### 3.9.3.3 Amendments to Sections 3.6.3.1 North South Streets

### 3.9.4 Amendments to Section 3.6.2.1 Tall Buildings

FIGURE 34. Commissioners Stack; from: Centre Street, Western end

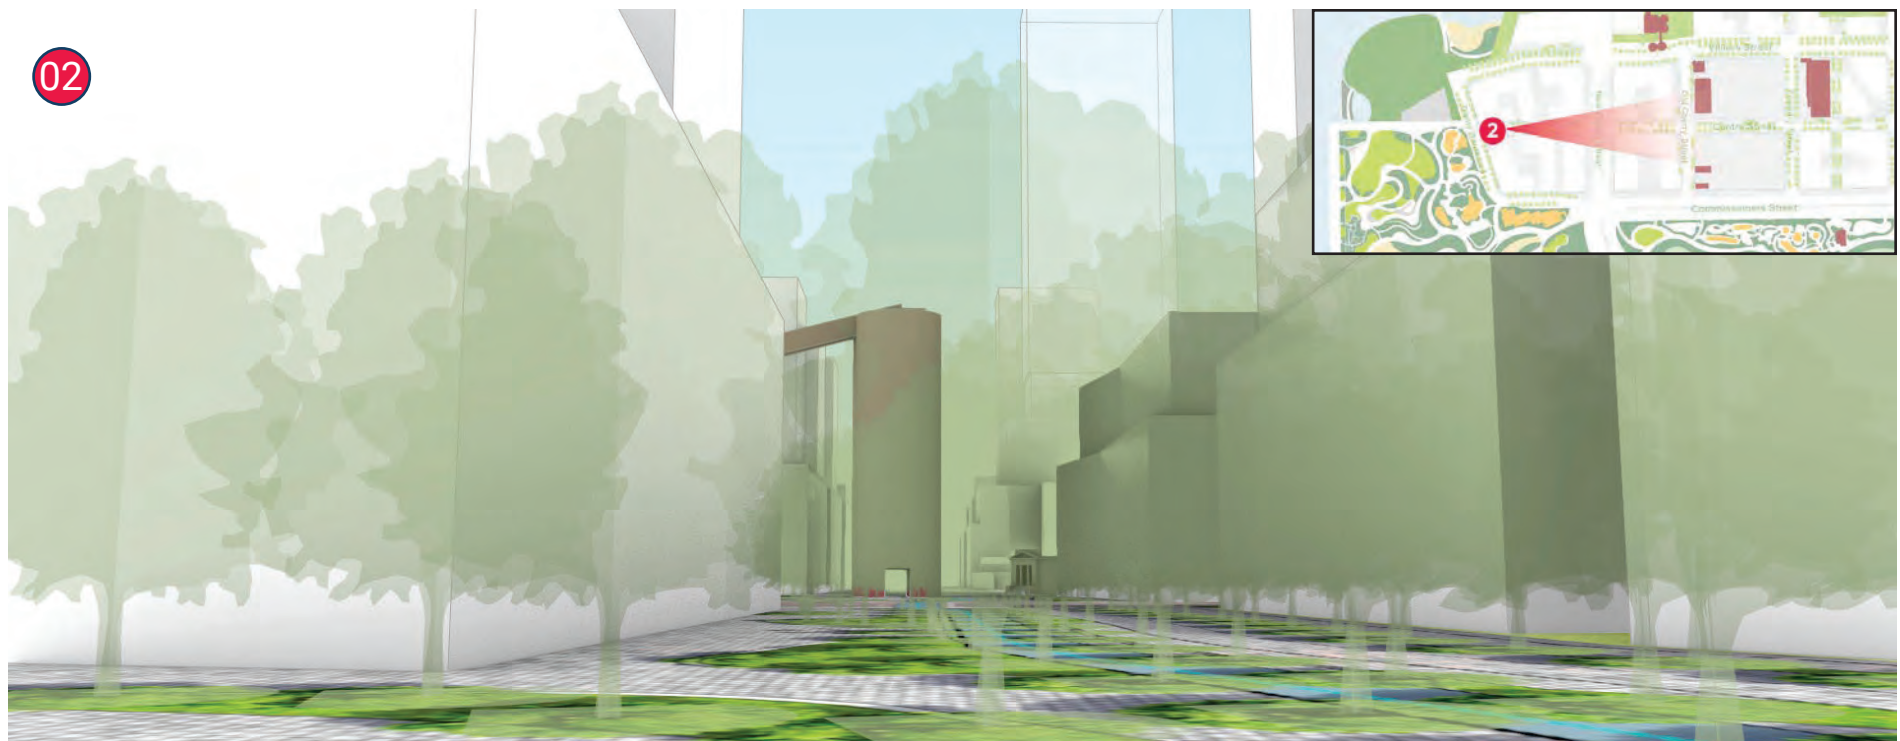
### 3.9.8.2 Amendments to Section 3.6.7 View 2: Commissioners Stack

2017 Precinct Plan	2024 Amendment
<p>An intimate, oblique view of the historic Commissioner’s Incinerator chimney stack, a totem of the Port Lands, will be achieved by generally aligning Centre Street in Villiers Island and a new east-west street in McCleary District to capture a long view of the chimney stack from the west, while preserving the historic Foundry building in its original location. Sky view will be provided around the chimney stack by stepping back development above a mid-rise height</p>	<p>The view along Commissioners Street, the longest street adjacent to the renaturalized river valley and River Park North, will maintain a strong park edge mid-rise scale with towers set back to not be dominant on the park. Transition in scale to the low-rise heritage resources along Old Cherry Street will create an aperture in the massing, allowing for sun access and sky-view to the Old Cherry heritage corridor.</p>

FIGURE 35. Villiers Street and Lake Ontario Portland Cement Company Silos; from: Promontory Park, looking east

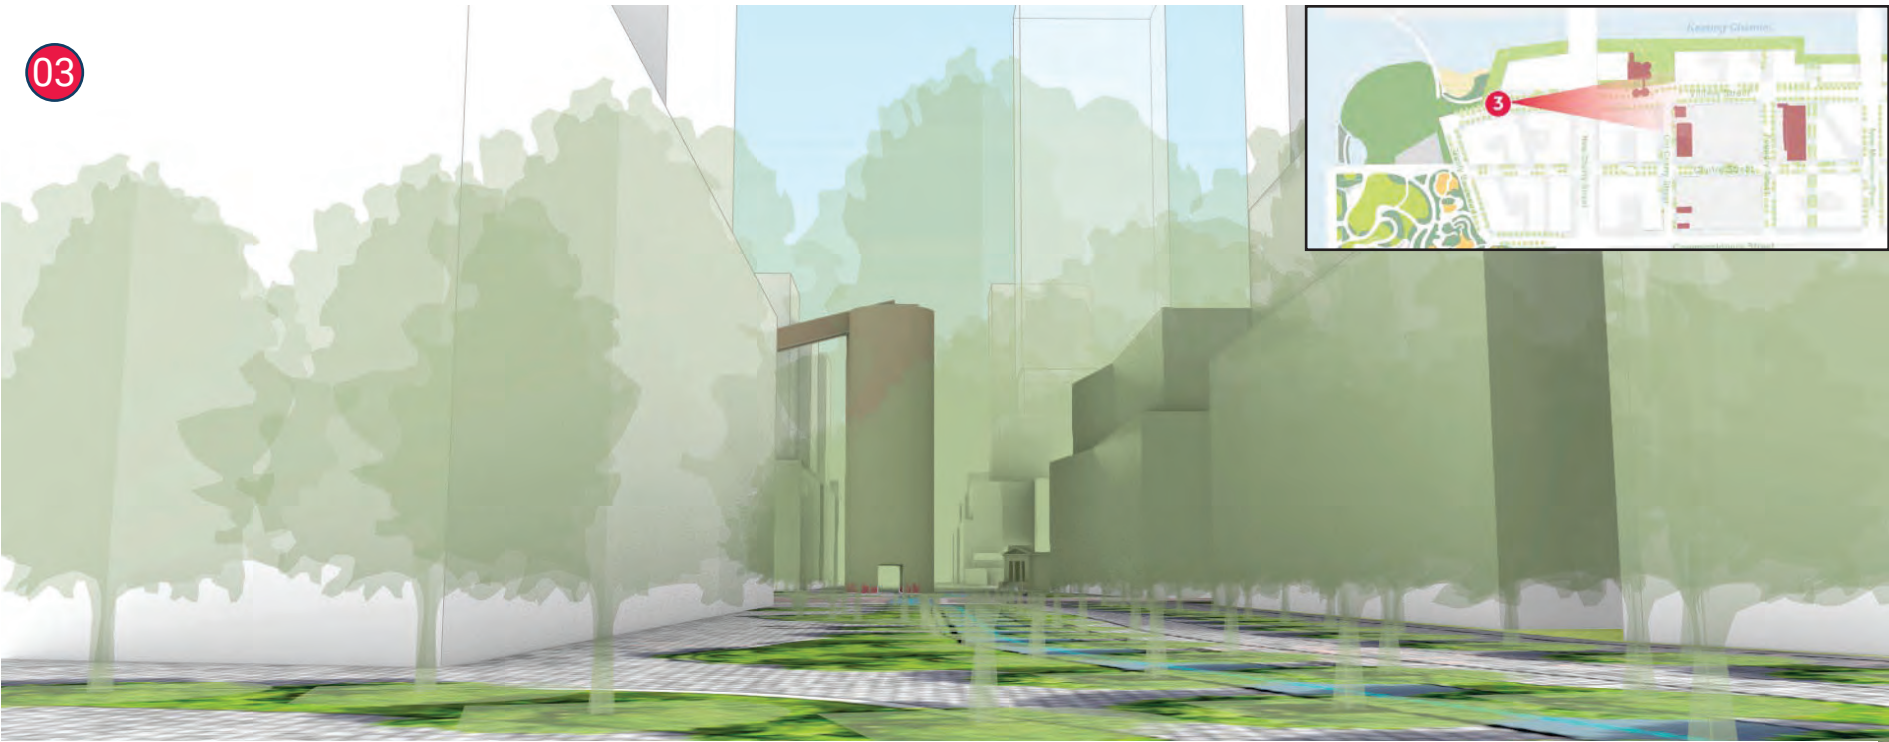
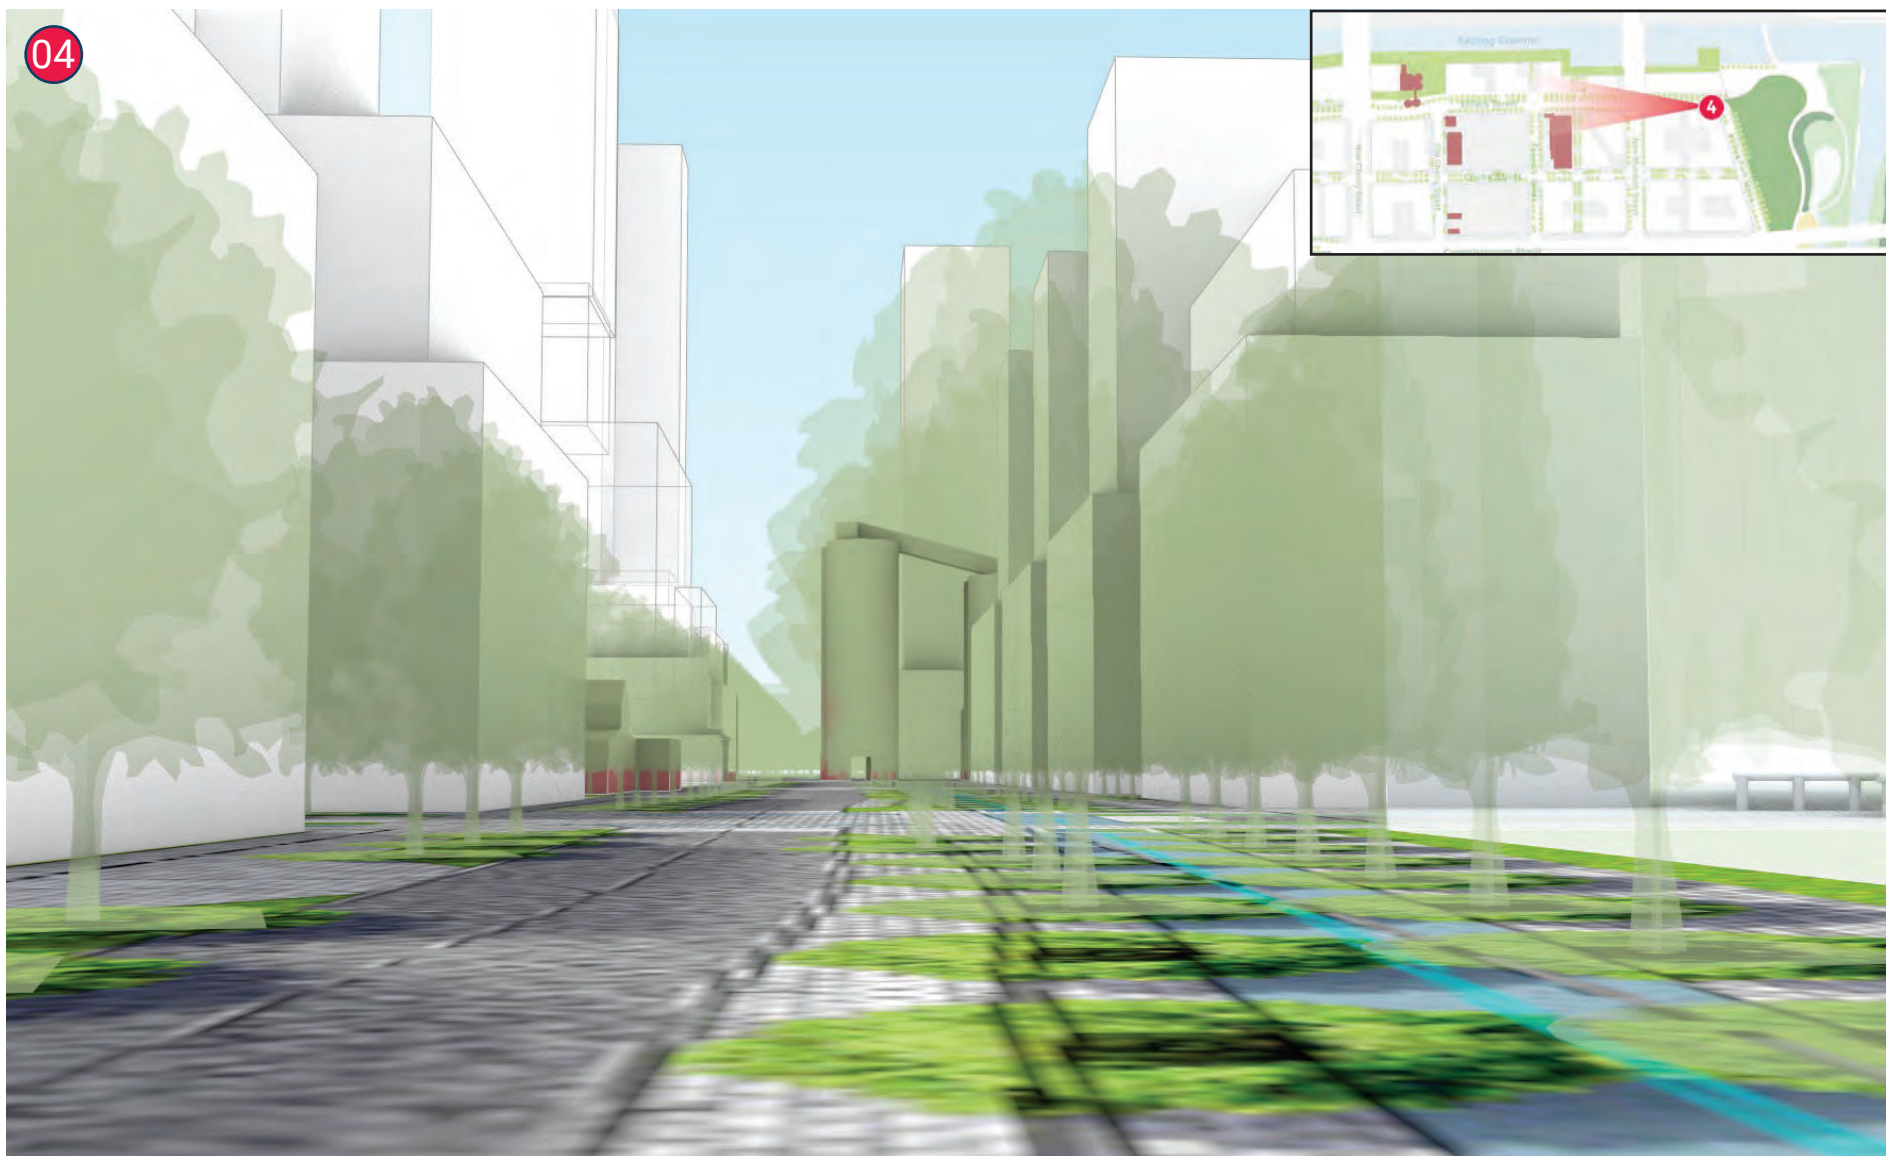
3.9.8.3 Amendments to Section 3.6.7 Views 3 and 4: Portland Cement Company Silos

2017 Precinct Plan	2024 Amendment
Views from the east and west along Villiers Street will be dominated by the dramatic scale and prominent location of the Lake Ontario Portland Cement Company Silos at existing Cherry Street, and lined to the north by the historic Toronto Harbour Commissioners buildings. The Silos will be a distinctive centre piece for the street as it evolves into a pedestrian priority retail / recreation destination. Development will frame the view, ensuring that buildings are sited and oriented to maintain the prominence of the silos through setbacks and/or generous stepbacks.	Views from the east and west along Villiers Street will be animated by the scale and prominent location of the Lake Ontario Portland Cement Company Silos at existing Cherry Street. The Silos will be a distinctive centre piece for the street as it evolves into a pedestrian priority retail/recreation destination. Development will frame the view, ensuring that buildings are sited and oriented to maintain the prominence of the silos through setbacks and/or generous stepbacks.

FIGURE 37. Keating Promenade, Lake Ontario Portland Cement Company Silos; from: Marina Square, looking west

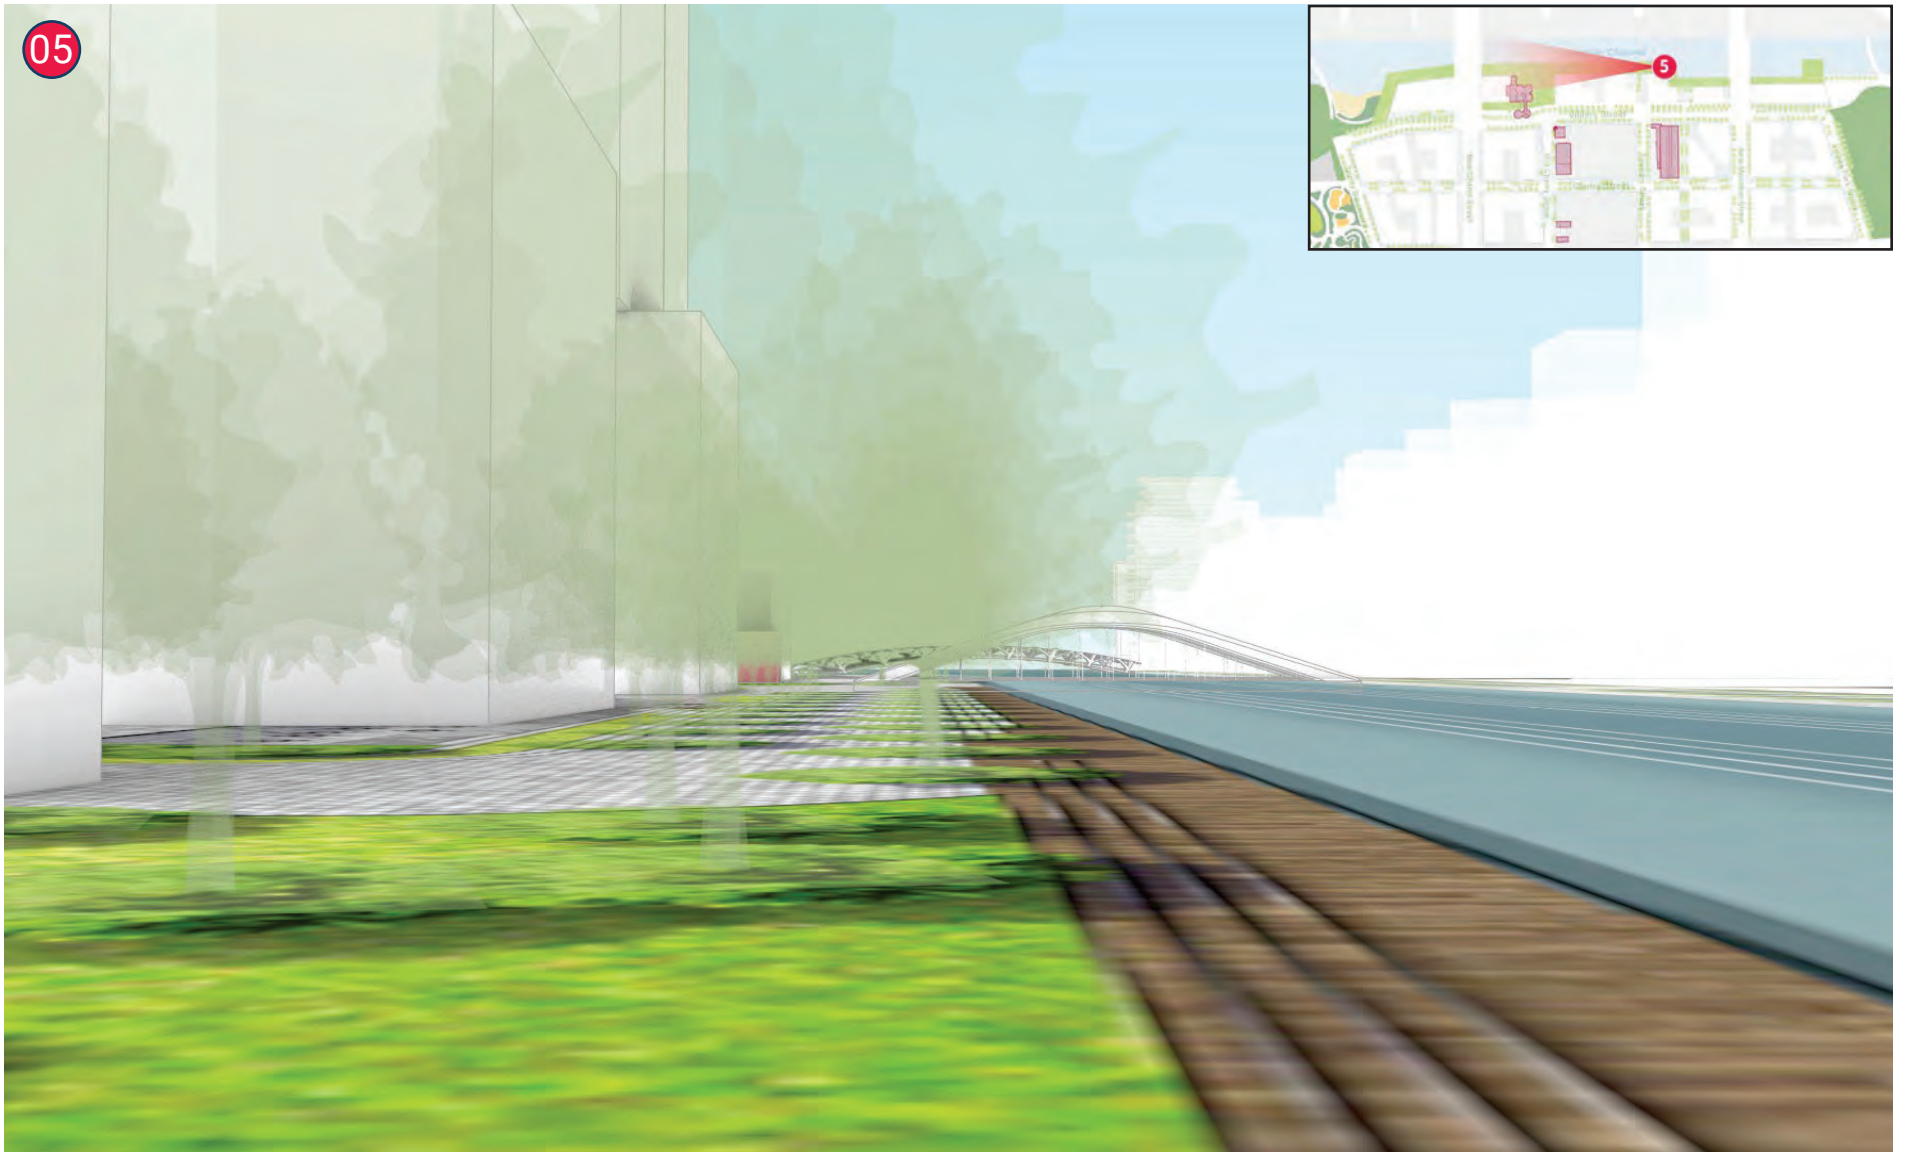
3.9.8.4 Amendments to Section 3.6.7 Views 6\*: Keating Channel and Lake Ontario Portland Cement Company Silos

2017 Precinct Plan	2024 Amendment
<p>The Keating Channel, an important heritage asset and reminder of the Don River’s historic reconfiguration, provides long views down the Channel to Villiers Island and emerging neighbourhoods in the Central Waterfront. This view prominently features the Lake Ontario Portland Cement Company Silos and Toronto Harbour Commission buildings, conveying a strong sense of place and celebrating the Port Lands heritage. Development adjacent to the Keating Channel Promenade will be low-rise in nature and be massed to maintain the prominence of the historic resources.</p>	<p>The Keating Channel, an important asset and reminder of the Don River’s historic reconfiguration, provides long views down the Channel to the Island and emerging neighbourhoods in the Central Waterfront. This view prominently features the Lake Ontario Portland Cement Company Silos, conveying a strong sense of place and celebrating the Port Lands heritage. Development adjacent to the Keating Channel Promenade will be massed to maintain the prominence of the built heritage resources.</p> <p>*Note that “View 5” from the 2017 Precinct Plan has been removed; the 2024 Amendment’s “View 5” replaces the 2017 Precinct Plan’s “View 6”</p>

FIGURE 38. View of Old Cherry Street; from: Commissioners Street, looking north

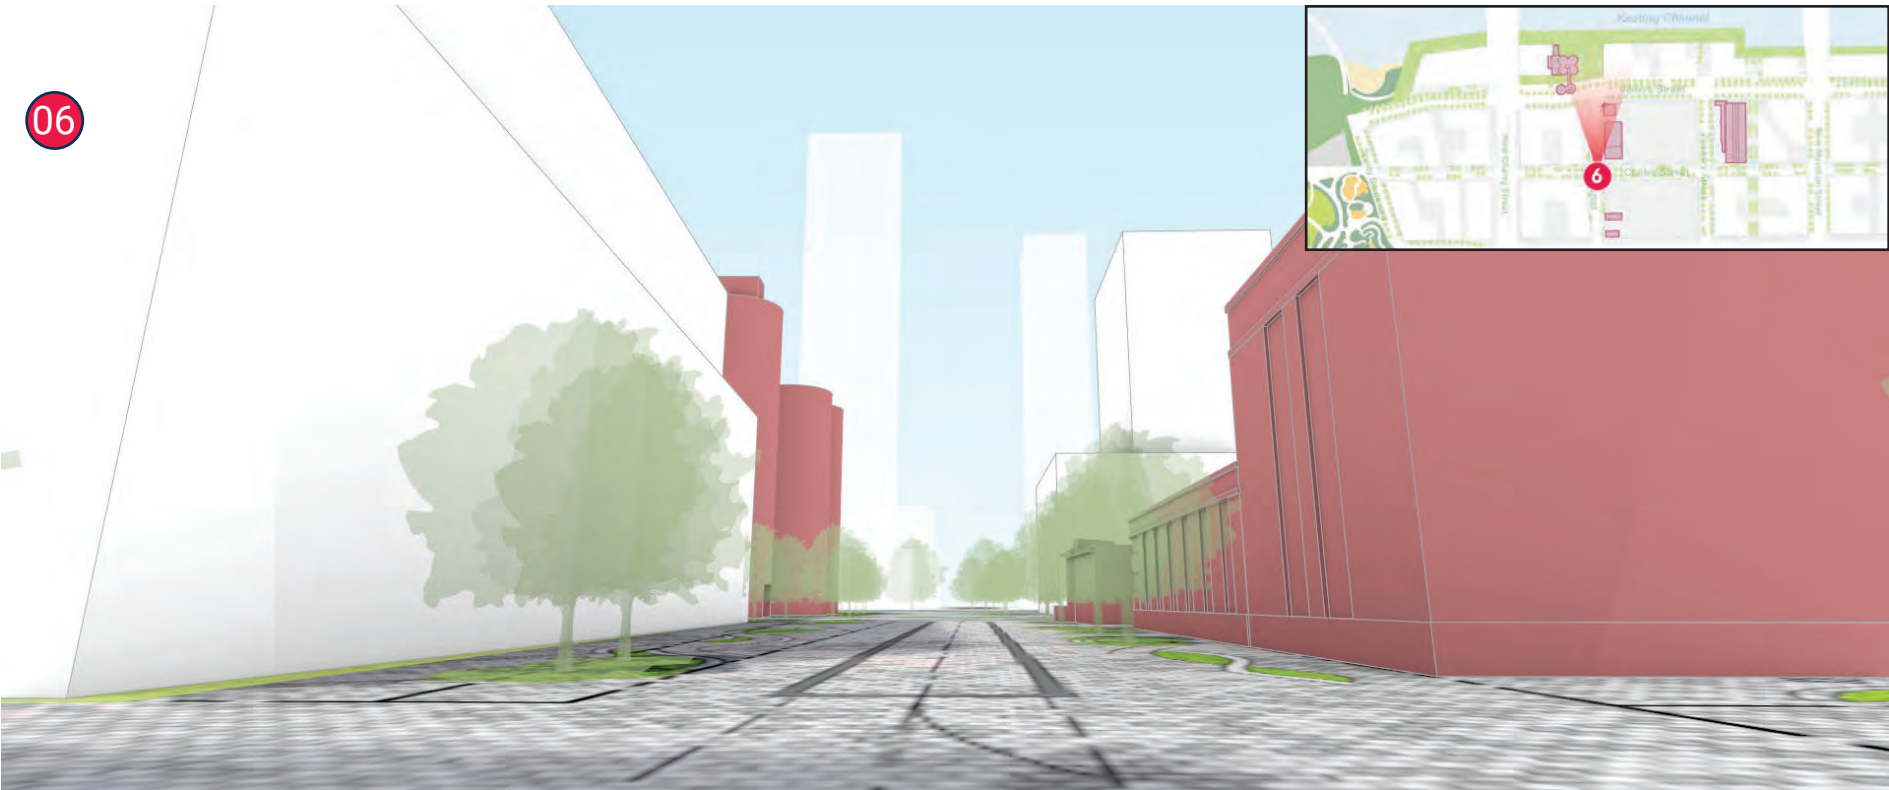
3.9.8.5 Amendments to Section 3.6.7 Views 7 and 8\*: Old Cherry Street

2017 Precinct Plan	2024 Amendment
The view looking north on Old Cherry Street from Commissioners Street is framed by the Lake Ontario Portland Cement Company Silos to the west, and a cluster of heritage buildings to the east. Development along the east side of Old Cherry Street will be massed and sited to preserve views of these buildings and complement their low-rise scale. The tower elements within the Keating Precinct are seen further afield.	Views north to the silos and the Keating Channel, and south to the river valley will be prioritized along the Old Cherry heritage corridor. Built form will frame views to the silos and transition appropriately to the low-rise heritage resources along Old Cherry to prioritize ground level views, sky view and optimal sun access to animate the public realm at this key location.  *Note that the 2024 Amendment’s “View 6” and “View 7” replace the 2017 Precinct Plan’s “View 7” and “View 8”

FIGURE 40. View of Fire Hall No. 30 looking east; from: Commissioners Street

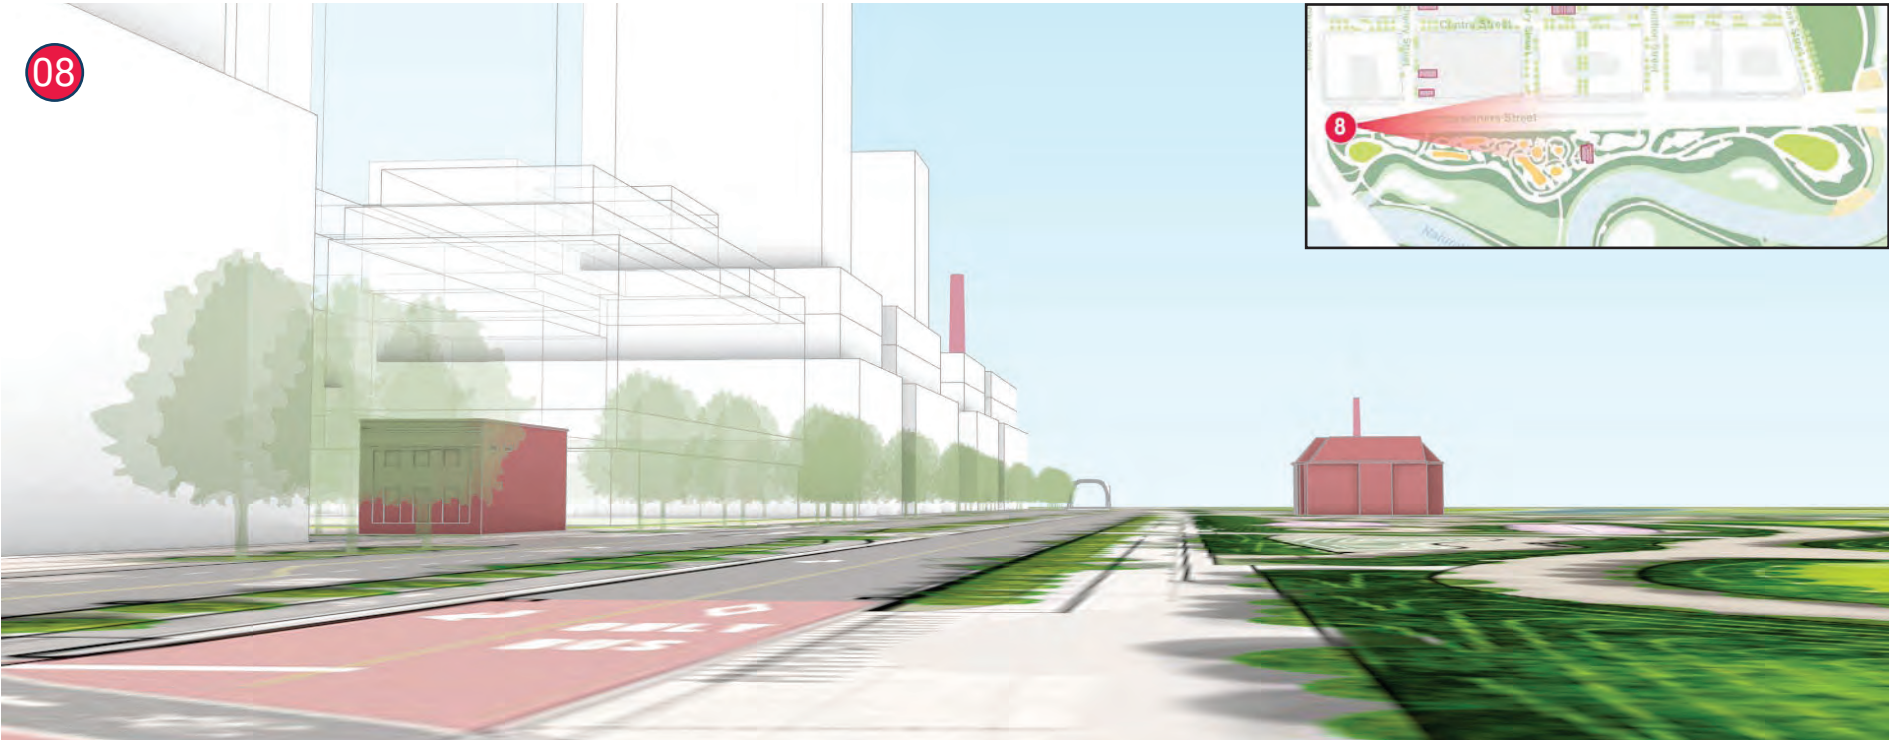
3.9.8.6 Amendments to Section 3.6.7 View 9\*: Commissioners Street and River Park

2017 Precinct Plan	2024 Amendment*
Views east and west along Commissioners Street will feature naturalized landscapes, including the new River Valley, estuary, and River Park to the south, and mid-rise built form to the north. The view corridor also provides direct views of Fire Hall No. 30, located adjacent to Commissioners, and the Hearn’s chimneystack.	No change; included to demonstrate revised massing within view corridor.  *Note that the 2024 Amendment’s “View 8” replaces the 2017 Precinct Plan’s “View 9”
